PD Modification Application: MM 24-1152

**Hillsborough
County Florida**

Development Services Department

1.0 APPLICATION SUMMARY

FIGURE 1

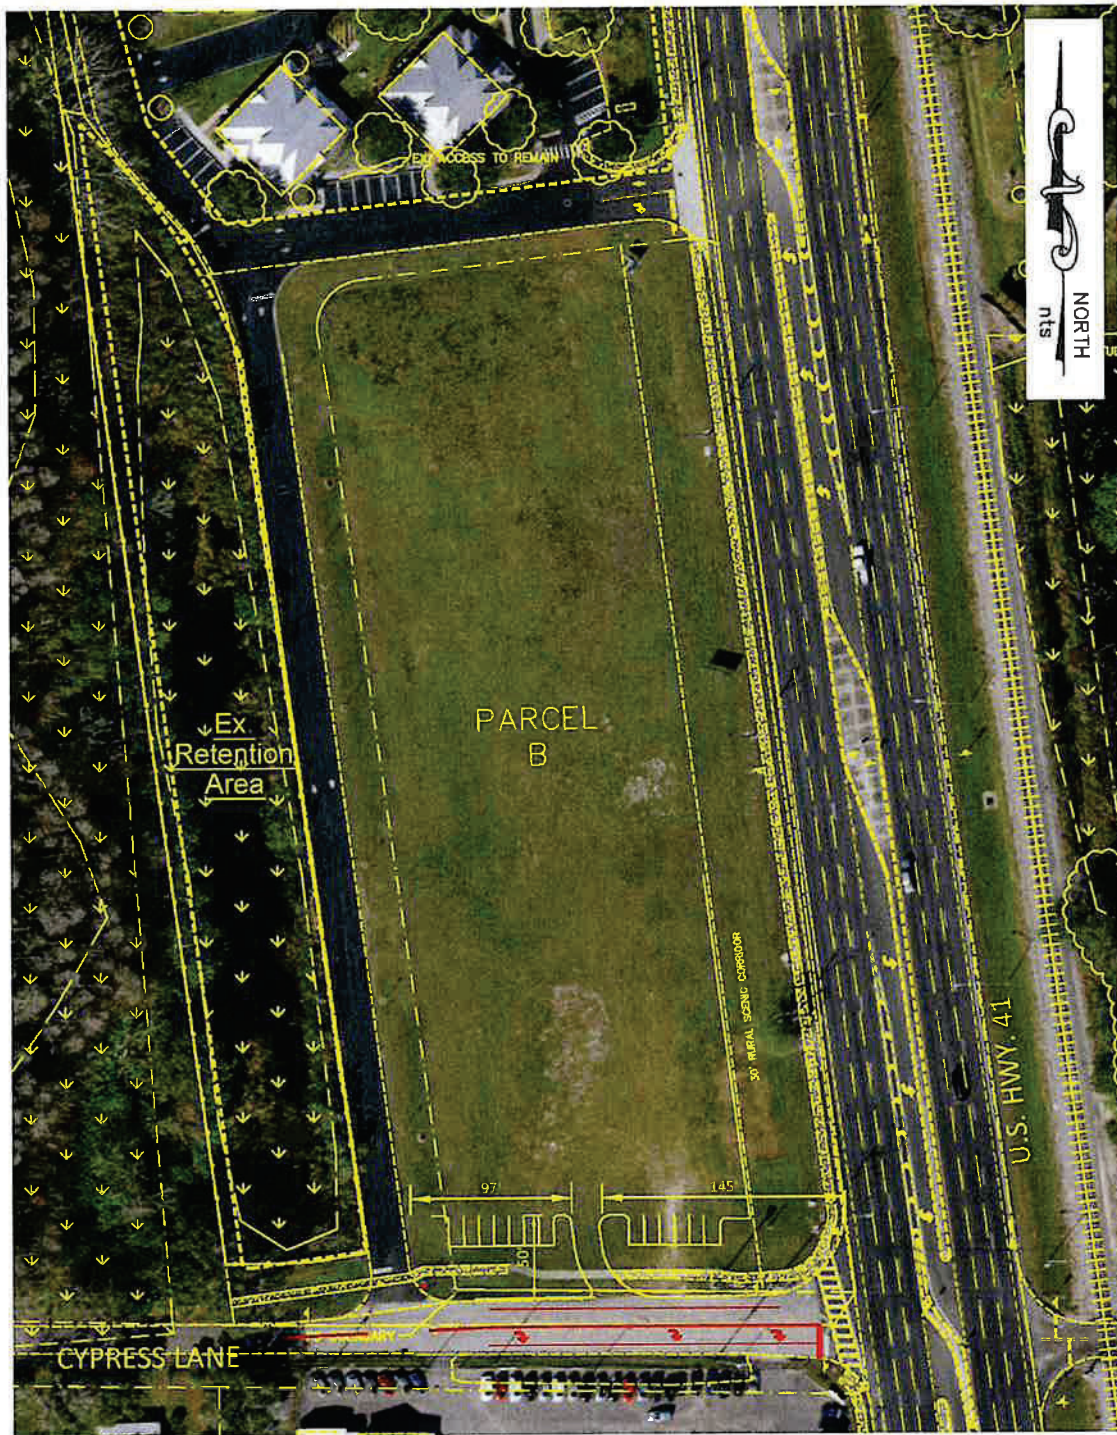
1. The developer proposed to add the following improvements to Cypress Lane:
 - a. Restripe Cypress Lane from US 41 to the western access to provide 11 foot lanes and 6 foot bike lanes.
 - b. Provide 5 foot sidewalk on the north side of Cypress Lane.

Figure 1 illustrates the proposed improvements and Figure 2 illustrates the proposed typical section.
